**AUC INSERTIONS TO REFLECT
NRC TALKING POINTS
OPEN/CONFIRMATORY ISSUES**

AUC insertions are all in red text. Text in normal print is explanatory in nature. *Text in italics represent AUC's proposed language for revising the TR.*

Note the map, Fig 2.7A-8 and cross sections Fig 2.6A-12 and Fig 2.7B-18 below.

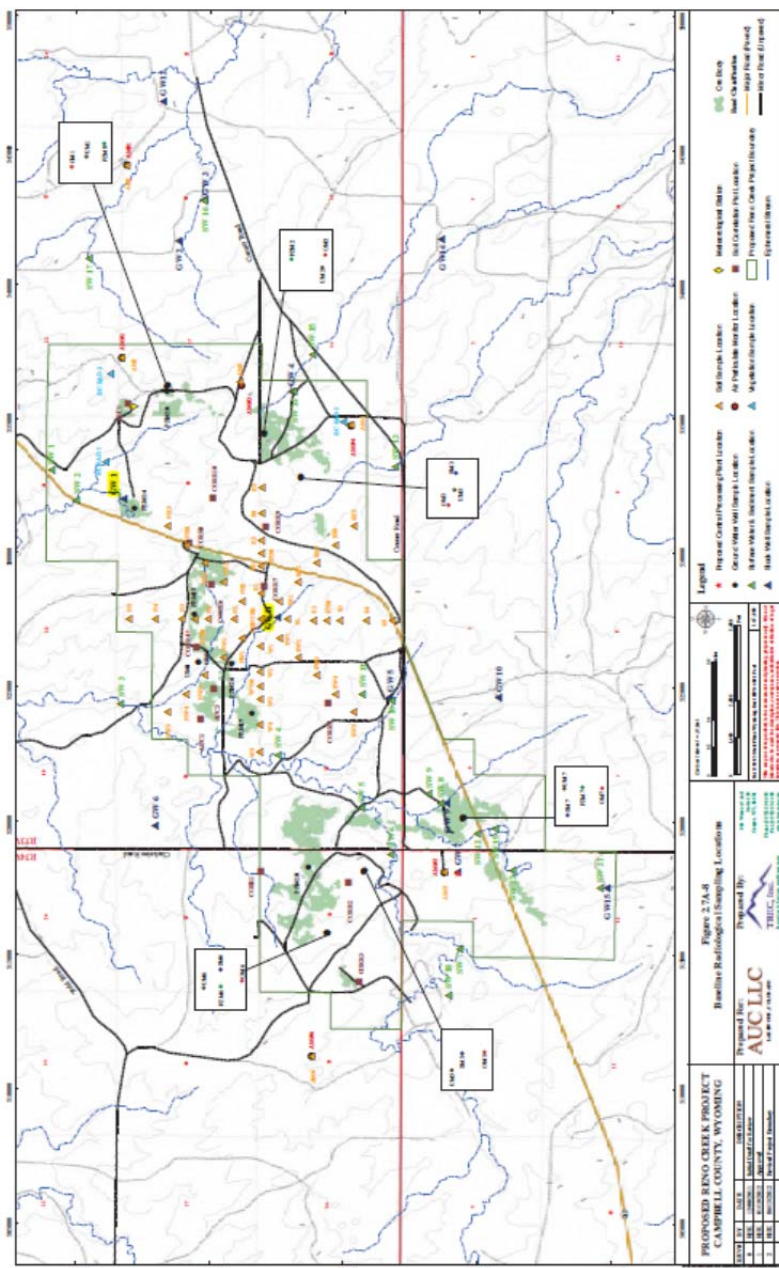
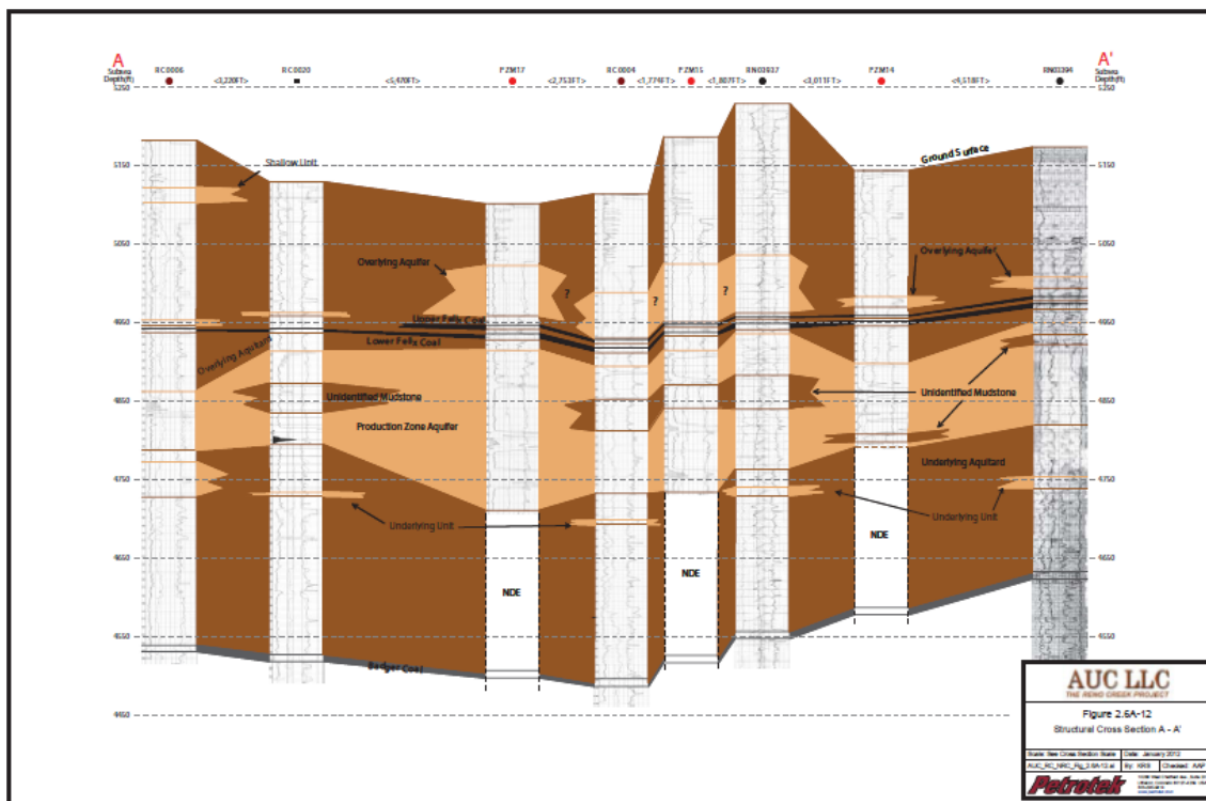
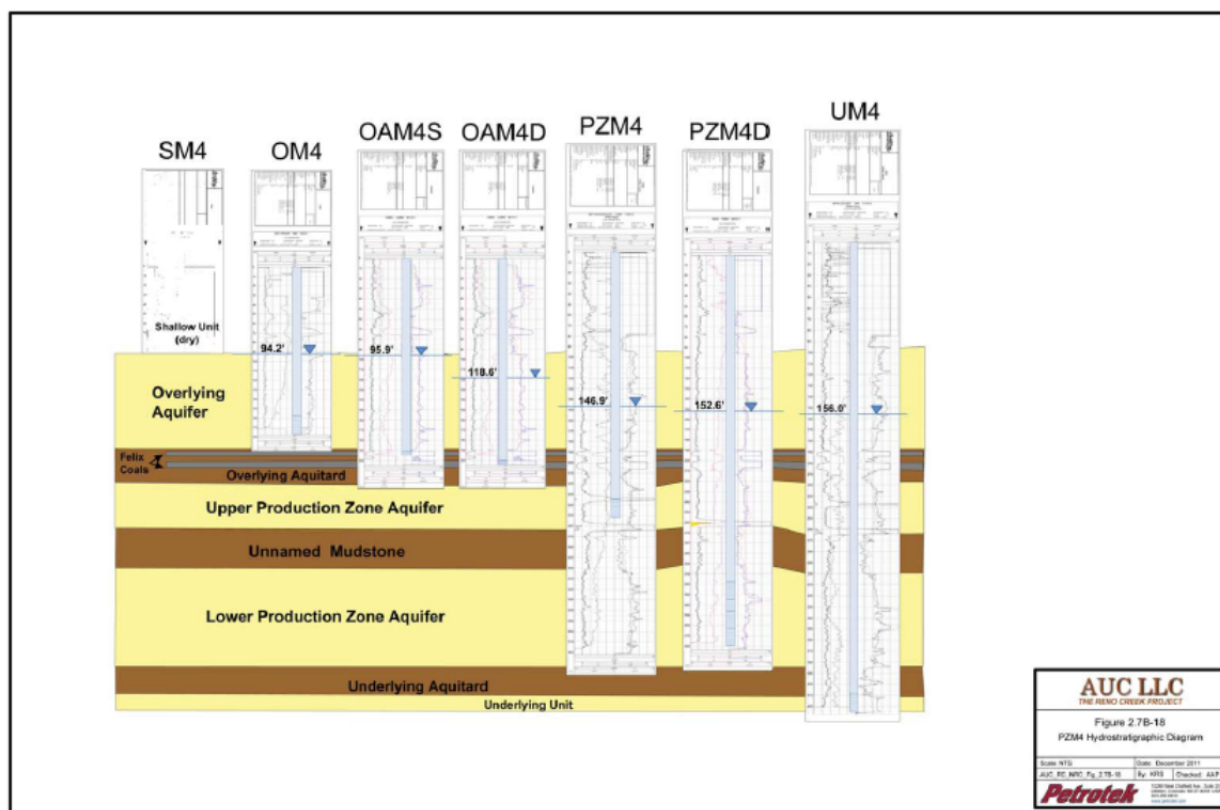
AUC states that the SM unit is perched, non-contiguous and low yielding and thus is not an aquifer. If the SM unit is not an aquifer it cannot be the uppermost aquifer.

Staff does not find the arguments in the application and responses to staff's RAIs that the SM unit is not an aquifer. Two nearby livestock water supply wells are screened at depths consistent with the depth for the SM unit (Summary of Wells Sampled for Pre-Operational Environmental Program (revised December 2014) on page 2-65). AUC needs to commit to modifying the TR to remove references that the SM unit is not an aquifer.

AUC agrees that stock wells GW1 and GW 11 may be reasonably interpreted to occur in the surficial hydro-stratigraphic zone, lying above the Overlying hydro-stratigraphic zone. All other stock wells in the Permit Area are most reasonably to be interpreted to occur in the Overlying hydro-stratigraphic zone. AUC specifically tested the surficial hydro-stratigraphic zone with 7 wells. This gives us 9 wells that clearly tested the hydrologic capacity of the actual or potential surficial hydro-stratigraphic zone that neither GW1 nor GW11 has construction details, logs, or aquifer tests. They just show the TD and existence of water. Stock wells are used seasonally, but only for a few weeks during the summer when cattle are brought to a particular pasture.

The data do not support the notion that the SM hydro-stratigraphic zone is a regional aquifer. The SM may be reasonably characterized as locally exhibiting some aquifer characteristics with a limited areal extent.

AUC agrees to revise the TR to remove references that the SM is not an aquifer and to describe it with the above characterization.

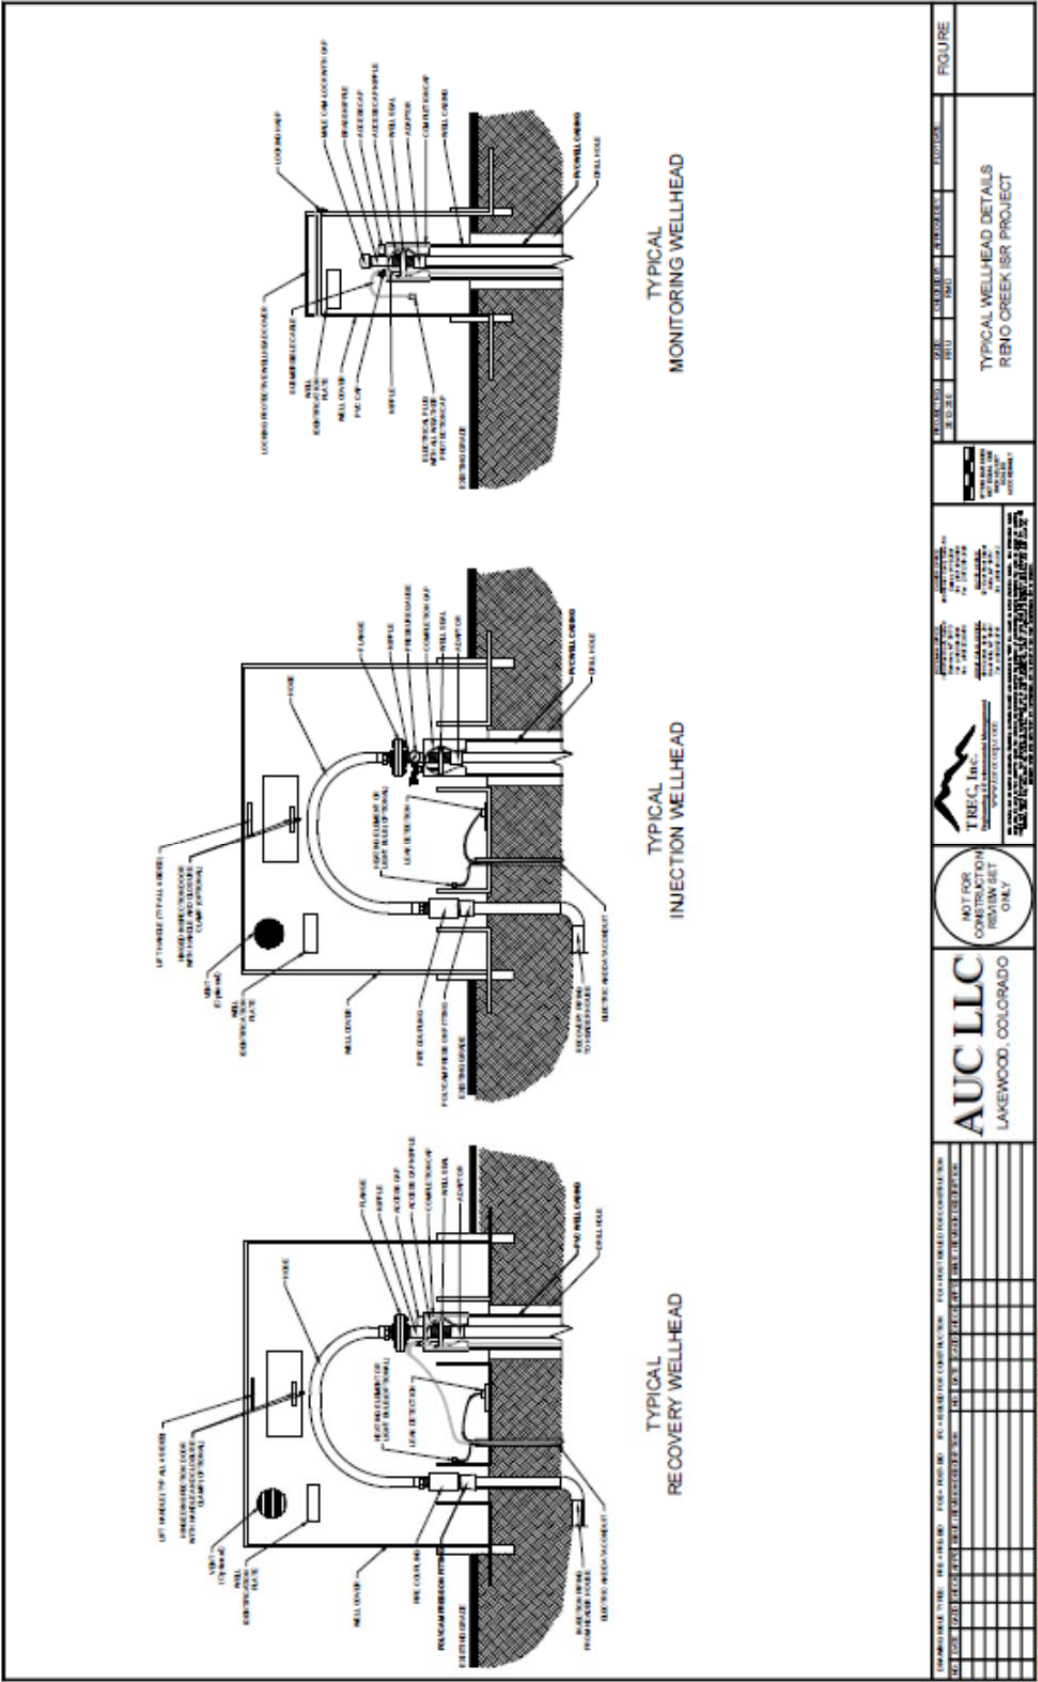
1(i) Draft SER Section 3.1.3.2 TR Section 7.2.5.2; RAI Response NA
Wellhead Protection Features

The applicant states that leak detection sensors will be included in the well head sumps but does not include a description of the wellhead completions. The details should discuss protection of the wellhead from accidental damage, freezing from cold temperatures and spills or leaks consistent with guidance in the Standard Review Plan. The wellhead enclosure will have the ability to contain small leaks and incorporate a leak detection system to notify the applicant of a leak before it is released to the environment.

Therefore, staff will require a commitment from the applicant to modify the application to include a diagram which depicts the wellhead completion details.

AUC will revise the TR to include the included diagram which depicts the wellhead completion details.

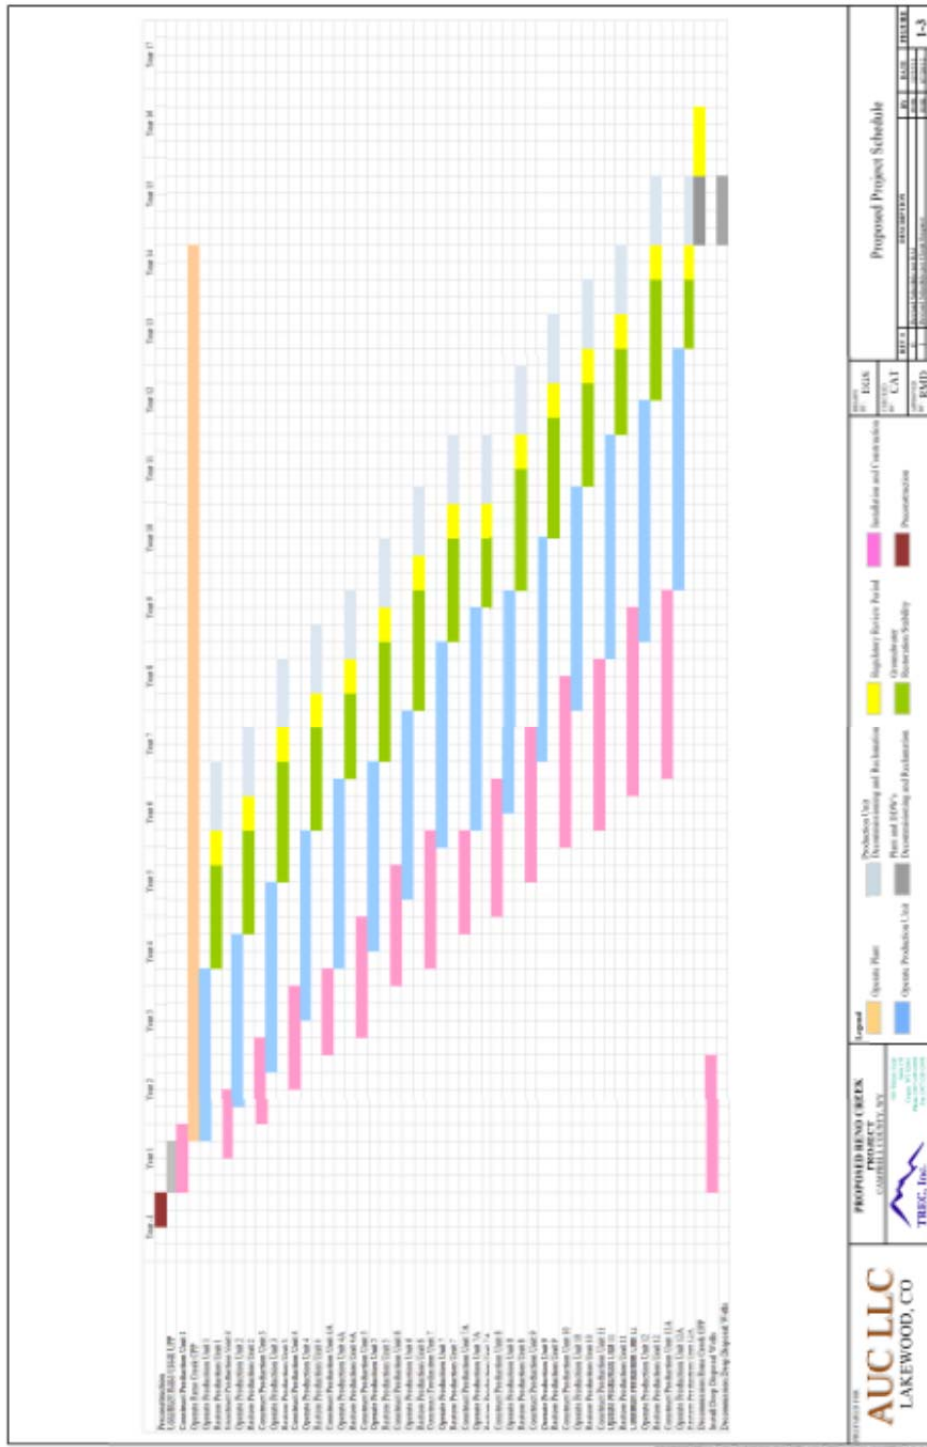
Proposed Project Schedule

RAI-2 stated if AUC commits to implement a phased decommissioning approach, revise Figure 1-3 (Proposed Project Schedule) to show how the approach affects the start of decommissioning activities, but AUC's revised RAI-2 response but did not include a revised Figure 1-3. Staff notes that AUC's revised RAI response package contains an Appendix F that includes a figure of the Proposed Project Schedule which appears to incorporate a couple changes that do not appear in Figure 1-3 (such as, preconstruction activities prior to installation and construction activities, and changes to the figure legend. The staff requests that AUC commit to ensure Figure 1-3 is consistent with any other Proposed Project Schedule for this application.

AUC agrees to revise the TR to reflect the modified Figure 1-3, attached below.

Figure 5-1: AUC Organizational Chart

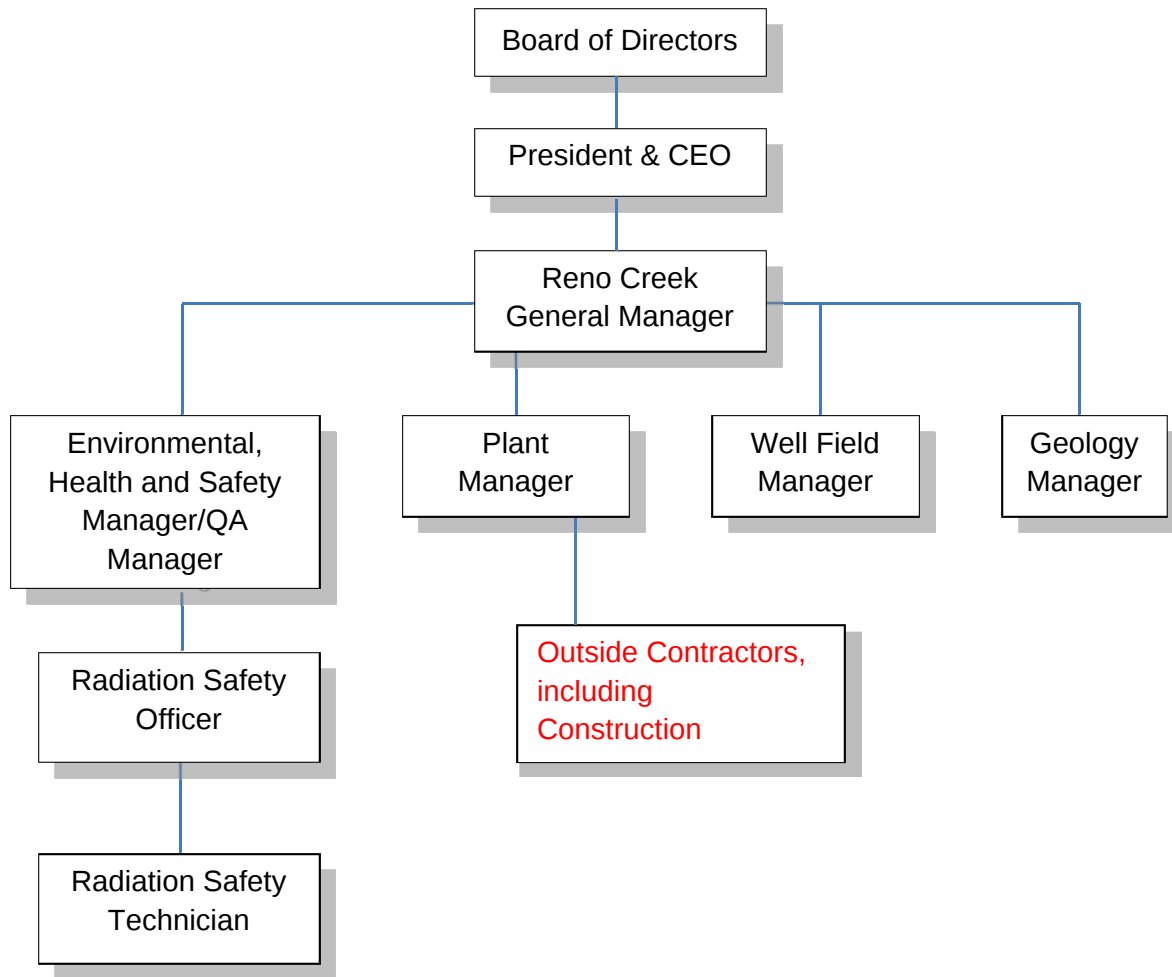
TR Section 5.1 does not address the integration between plant construction and plant management. Also, AUC's Organization Chart in Figure 5-1 shows the Plant Manager position under the General Manager, but it does not show where plant construction and plant maintenance are in the organization. The Standard Review Plan, Section 5.1.3, Acceptance

Criteria #2 states “The organizational structure shows integration among groups that support the operation and maintenance of the facility. If the facility is new, integration between plant construction and plant management should be detailed.” The staff requests that AUC add clarifying text in the TR to address the integration between plant construction and plant management. Also, clarify the role of the Plant Manager position in Figure 5-1 relative to the integration between plant construction and plant management.

AUC agrees to revise the TR to reflect the modified Figure 5-1, attached below. This figure shows that the Plant Manager is responsible for construction and vendor activities for the Project.
